Technical Review

To:	Shay McDonald	Date:	7 th September, 2026
Authority:	Otago Regional Council	Ref:	25080B
Consent:	Fast-Track Bendigo Ophir Mine		
From	Role in Audit		
Alexandra Badenhop	Surface water modelling, Groundwater & Geochemistry

1 Overview

Matakanui Gold Limited (MGL) and its advisors have compiled responses to the Expert Panel's Request for Information (RFI 11) Questions 1 to 9, which relate to water quality, hydrogeology, groundwater modelling, and contaminant transport. This review pertains to specific questions regarding the following documents:

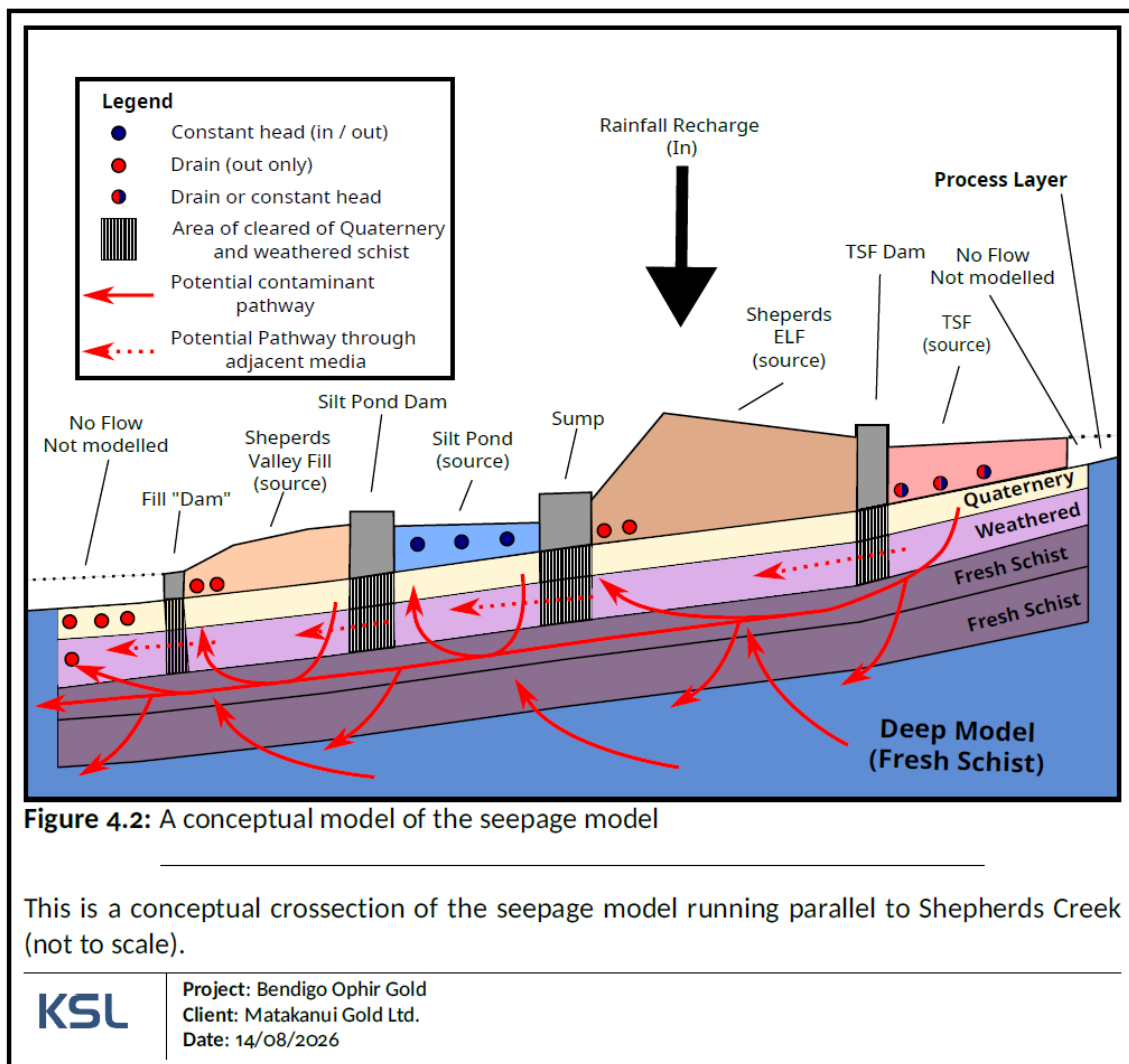
The silt pond and RAS pit and underground were originally included as contaminant sources, however initial model runs found that the RAS pit acted exclusively as a sink for contaminated water, and that the silt pond lost very little water, therefore these two sources were excluded from further model runs to reduce the processing time required. The Come In Time pit and backfill were not included in the modelling, nor any features in the Rise and Shine Creek Valley (Western ELF, SREX Pit and SREX ELF).
